OM651 Exhaust Bracket Cracking

Topic number	LI49.10-N-060969
Version	2
Design group	49.10 Exhaust pipes, catalytic converter, mufflers
Date	05-12-2016
Validity	Sprinter Model 906 with engine OM651
Reason for change	Part number change
Reason for block

Pic 1.jpg:

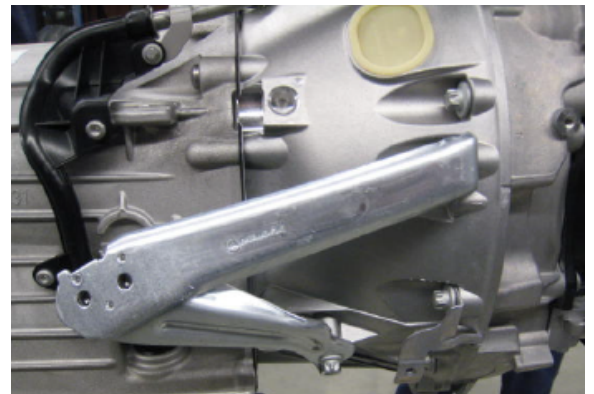
Inspect and replace exhaust bracket (Pic 1 & 3) as needed with current part number (check EPC for latest part number). Inspect bell housing for damage replace as needed. There is a new redesign exhaust bracket in preparation at the supplier. When the new part is available this LI will be updated to inform you of the new part number.
